CITY OF NAPOLEON
BUILDING CONSTRUCTION PERMIT
 (1, 2 or 3 Family Dwelling)

ELECTRICAL INSPECTION FIELD REPORT

Project Name RIA Bath

100 AMP SERVICE - CHANGE
 FROM 60 AMP SERVICE
 NEW DISTRIBUTION PANEL
 20 CIRCUIT W/ MAIN BREAKER
 IN BASEMENT 30" INSIDE WALL

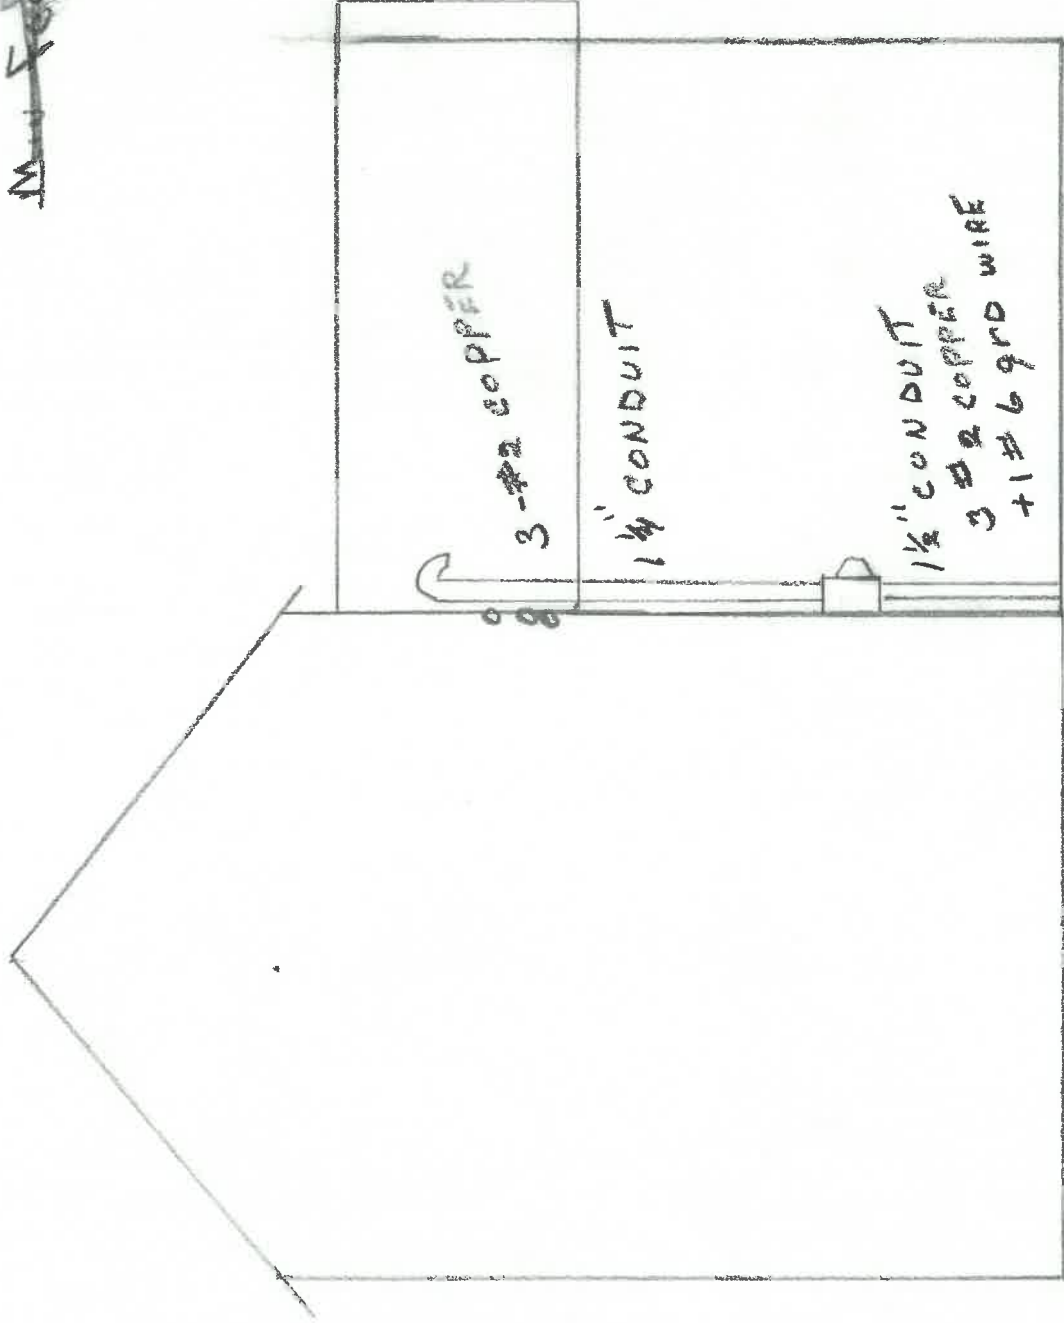
1) Neutral conductors in device box 370-6

4) Neutral conductors to be contained in 300-13

5) Romex to be protected by mechanical injury

6) Seal Service entrance to prevent condensation build up in pipe.

2) Grounds corrected & Rg inspected by Howes 6/26/75

3) Grounds corrected & Rg inspected by Howes 6/26/75
